SMDC Planning Reference –	DOC/2024/0069		
Site Name –	Rownall Road BESS		
Summary of proposals -	Review of Landscape Design Proposals – Materials Management Planning Information		
Consultation Note Subject –	Landscape and Visual Matters		
Planning Case Officer –	Principal Planning Officer		
Landscape comments prepared by –	Ryder Landscape Consultants		
Date(s) of site visit —	2022 & 2024	Date of this response	23/6/25
Number / Purpose of note	No.1 - To consider the submitted Materials Management Planning information and whether it satisfies Conditions 15 of Decision Notice SMD/2022/0444.		
Summary of consultation response	• That the proposal reduces transport and haulage disturbance to Rownall Road to a short stretch of the public highway. • That questions as to the depth of deposition are raised for the area of the receiving location. • That additional queries are raised with regards to land form shape, re-establishment of haulage and stockpile areas and effects to local surface water patterns. • That I do not consider that there is sufficient earthworks modelling and landscape reinstatement information provided to discharge the condition.

Cellarhead BESS (Rownall Road side) - Lan

Extract courtesy of Staffs CC PRow online map - [RightsOfWay Cadcorp SIS WebMap 9.1](#) accessed 23/6/25

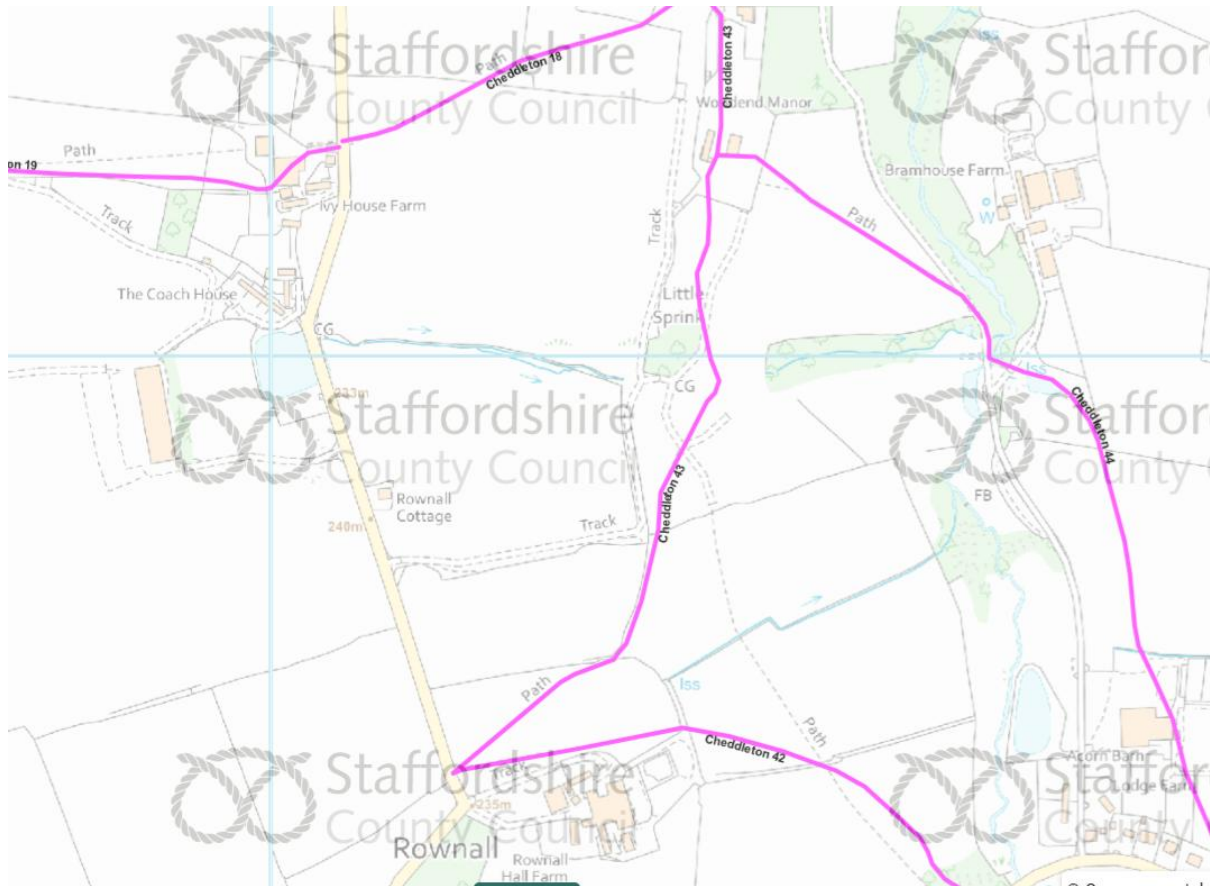
Without attending Site I cannot categorically confirm a definitive list of visual receptors but from looking at online mapping the following groups are likely to receive adverse visual effects:

- Users of Rownall Road during the construction period as wagoins are moved – temporary effect;
- Users of PRow Footpath Cheddleton 43 as it descends to the north and will require temporary stopping up or control as the haulage route would pass over it;
- Possibly users of PRow Cheddleton 44 depending on how far east the deposition area stretches, this footpath would not require stopping up;
- Residents at Coach House cottages and possibly at Woodend Manor.
